APPLICATION 25040461

**3 Patawaloga Frontage, Glenelg North, SA - Response to ODASA Referral Letter
APPLICATION 25040461**

The following responses are provided in relation to the matters raised within ODASA's referral letter dated 4 March 2026.

PATAWALONGA APARTMENTS

ROOF PLAN

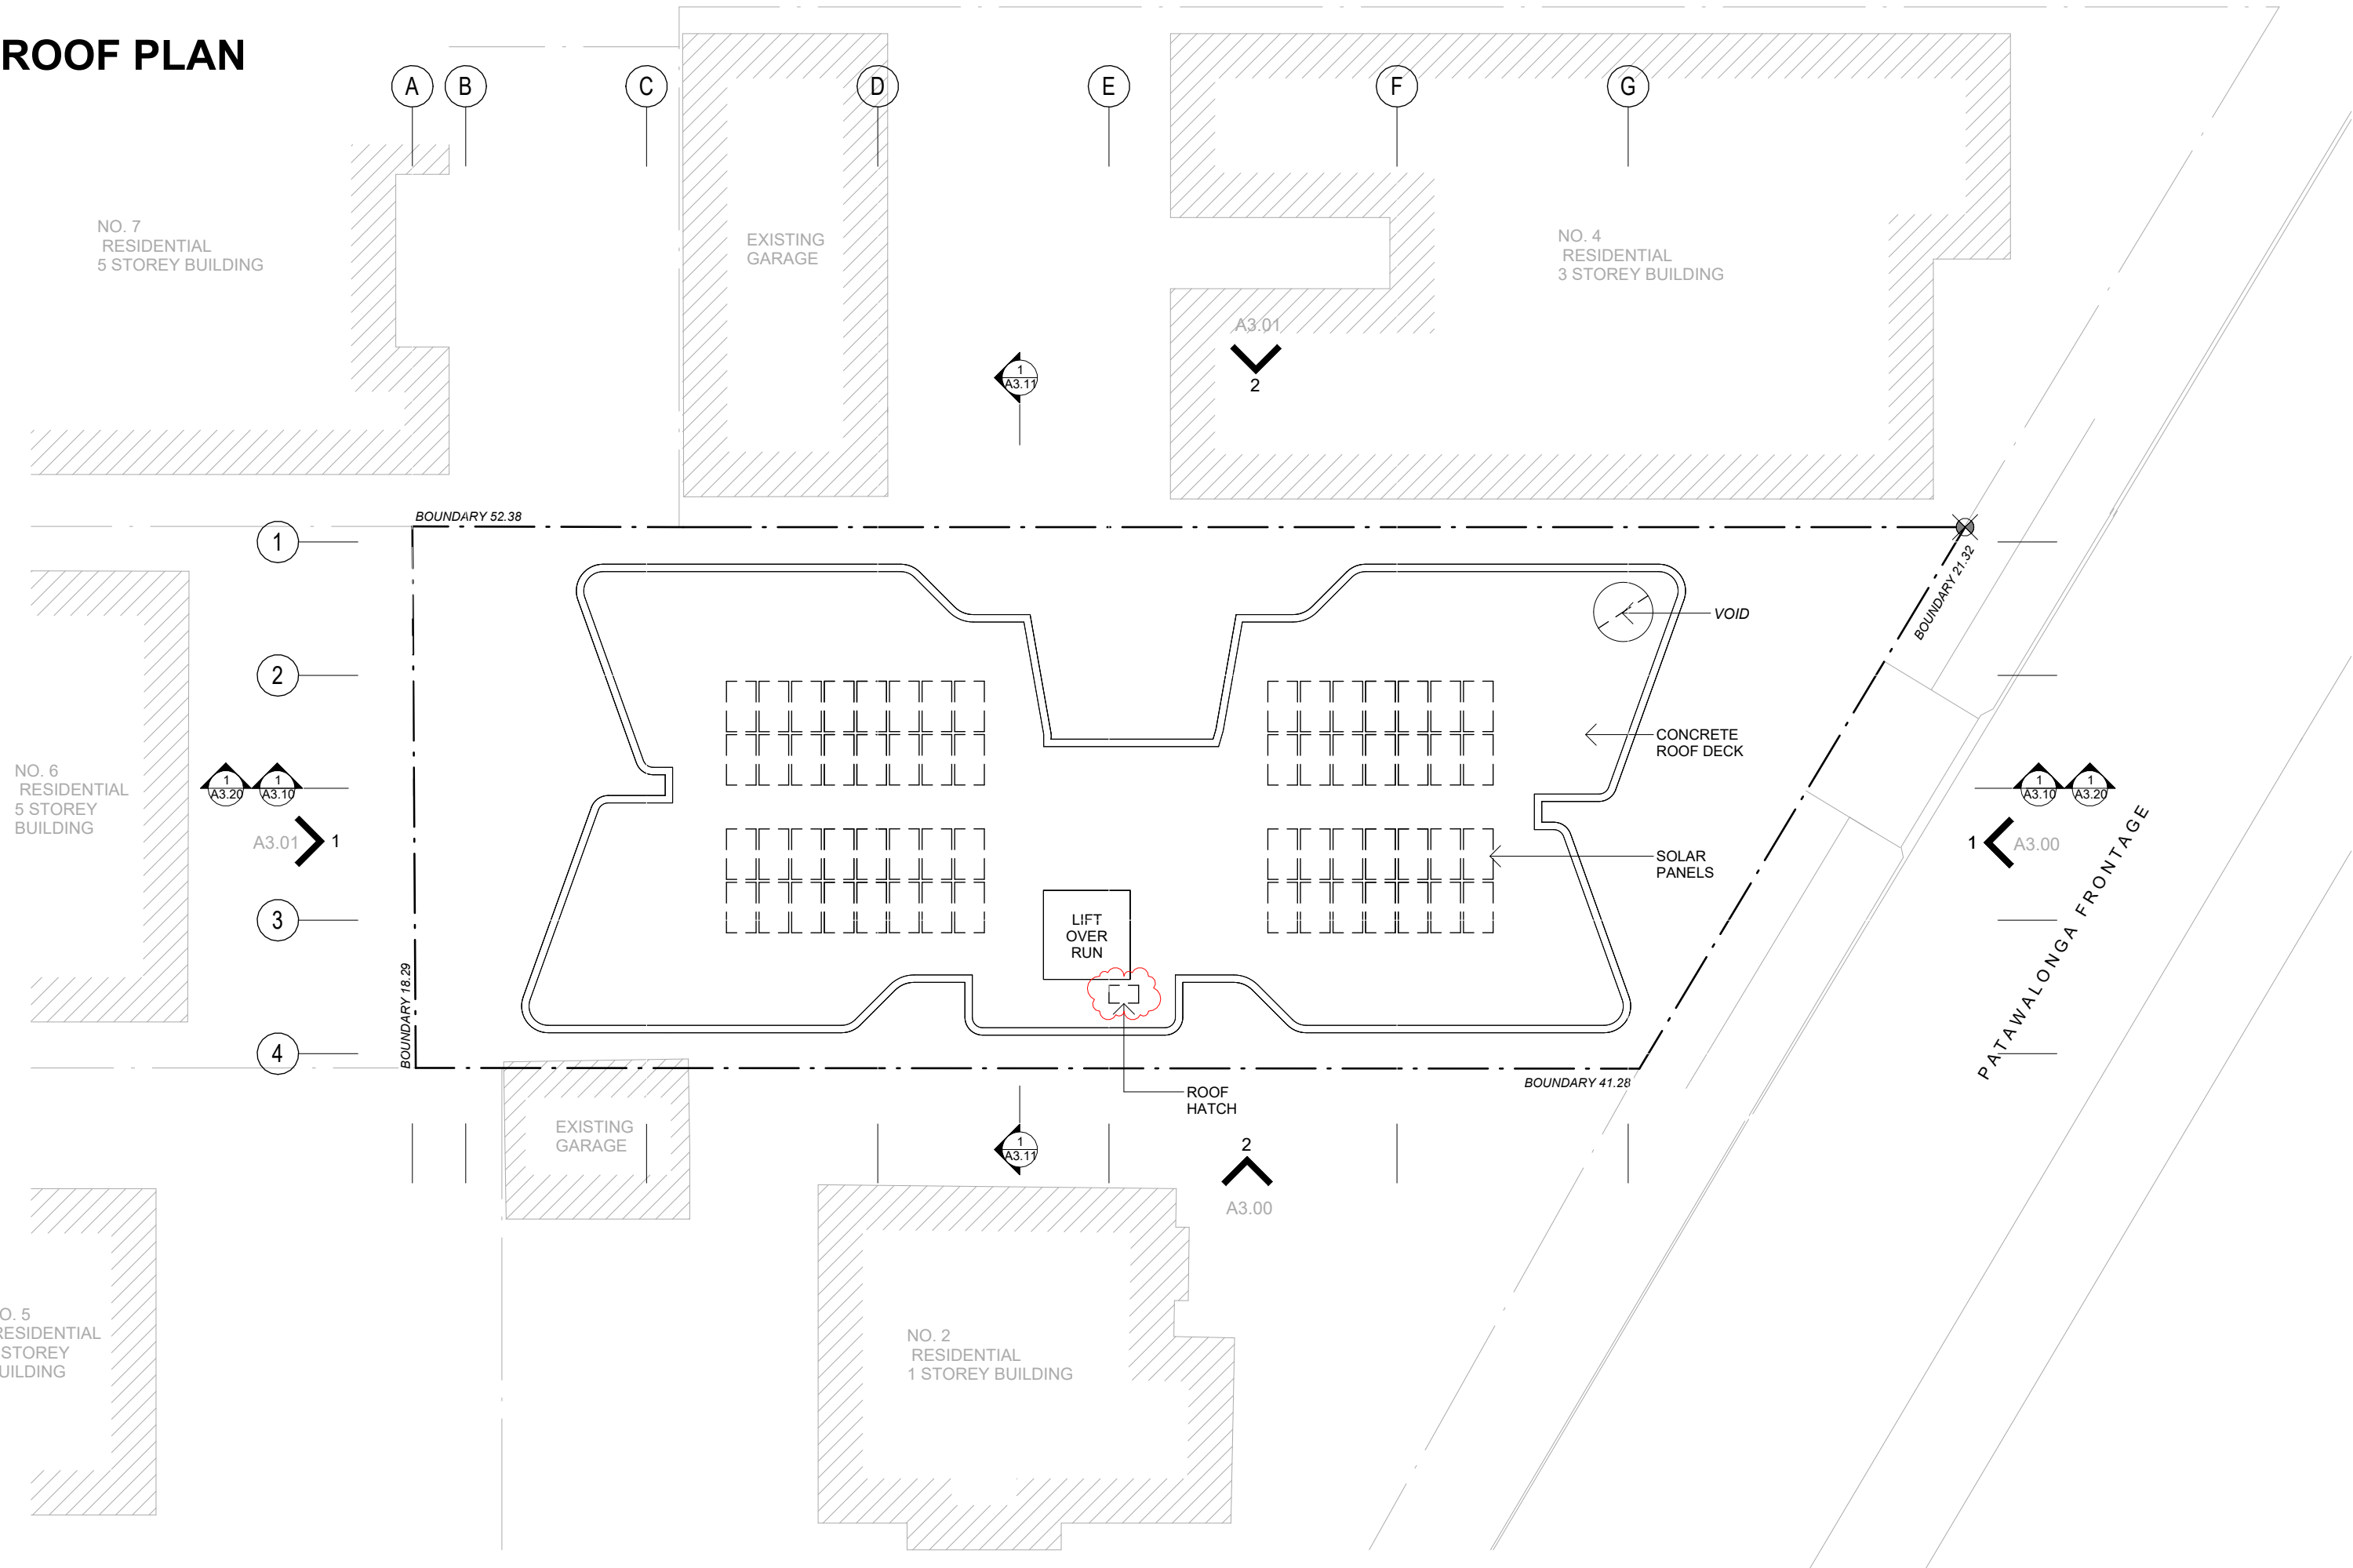
Confirmation of Roof Access

Refer to the updated Roof Plan (Drawing A2.05), which identifies an access hatch from the fire stair to the roof to facilitate maintenance access to the proposed solar panel infrastructure.

SOUTH ELEVATION

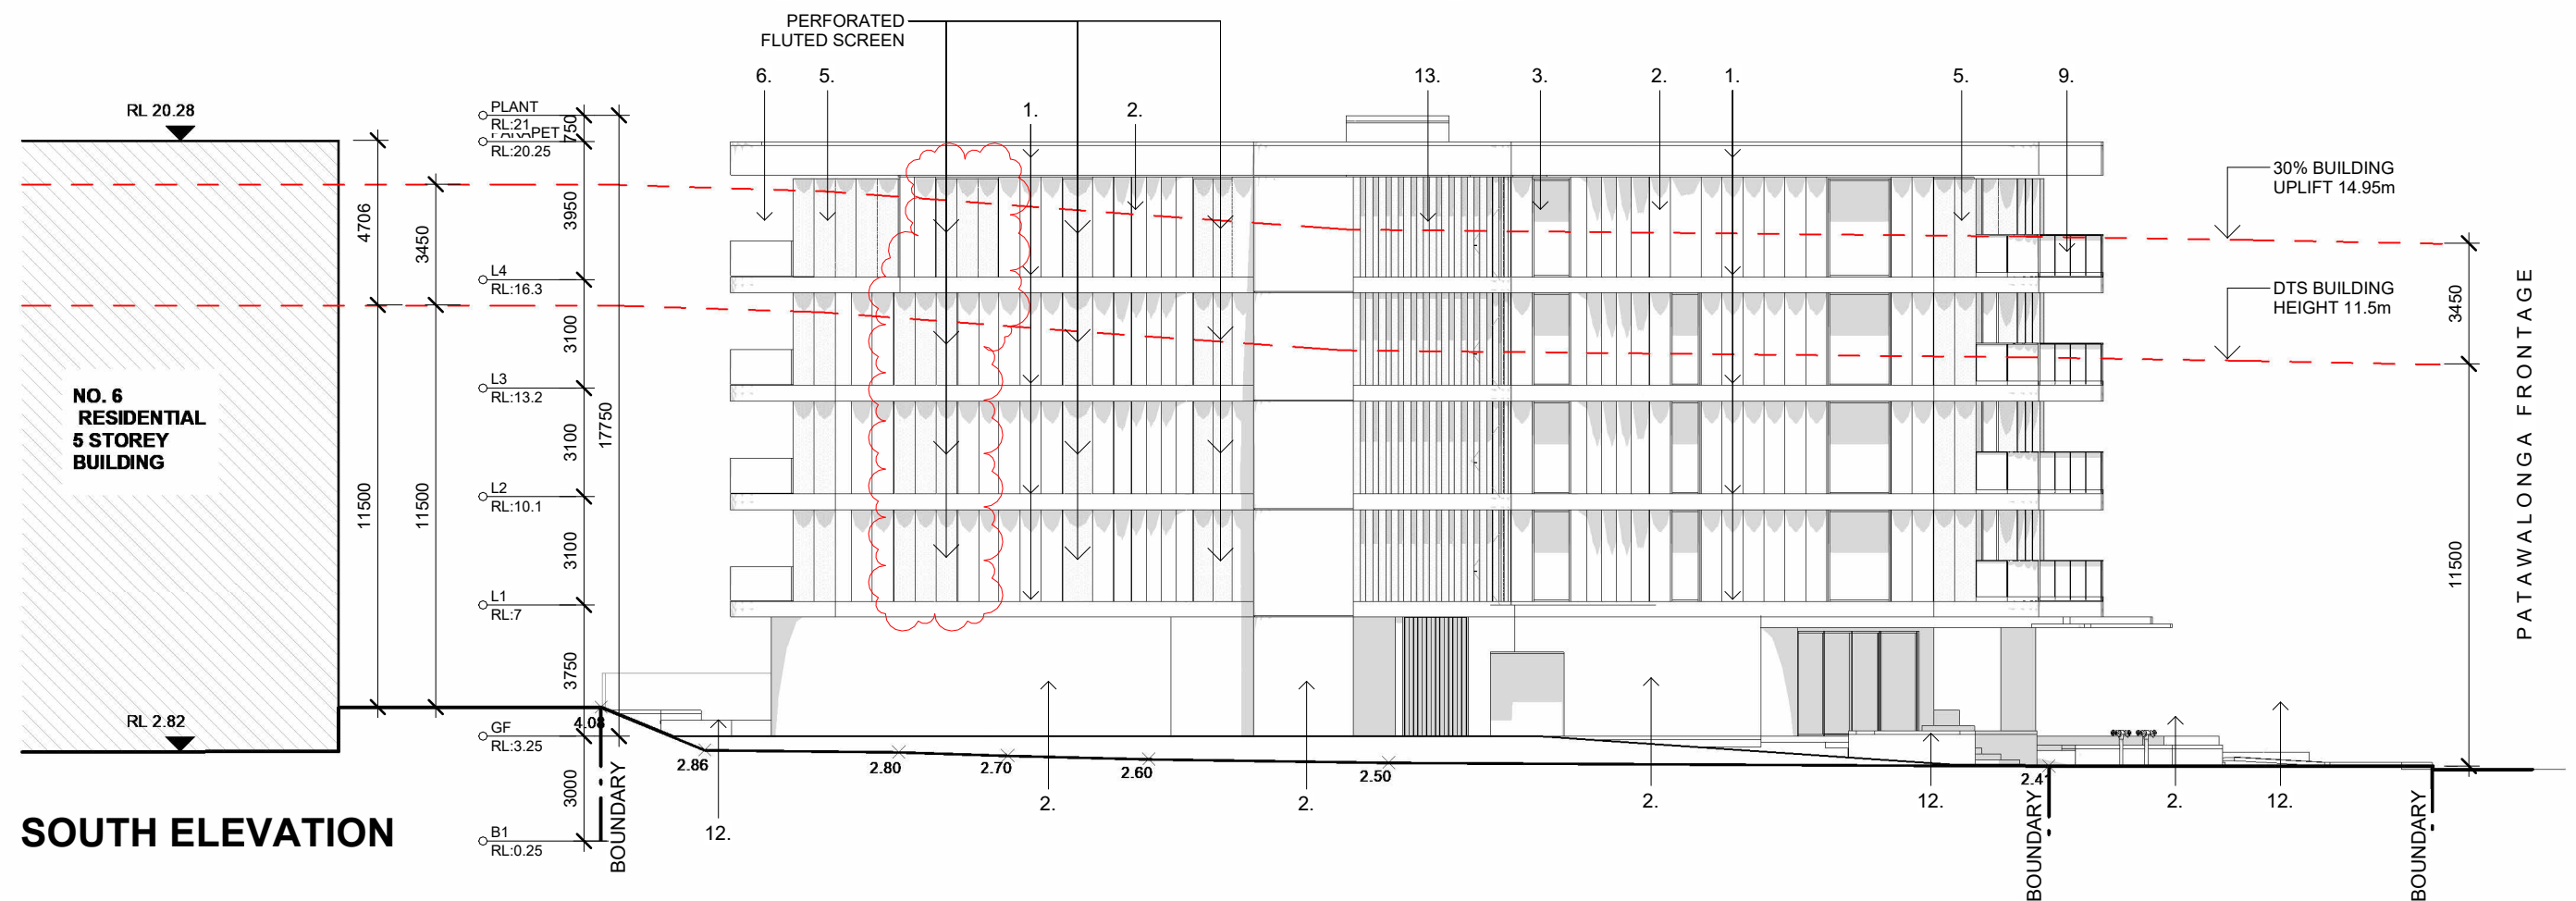
Windows and Screening

The southern elevation (Drawing A3.00) has been updated to incorporate perforated screening to the living room window in accordance with the screening diagram referenced on Page 30. All apartments have been designed for all habitable rooms including all bedrooms to have operable windows to allow for natural ventilation.
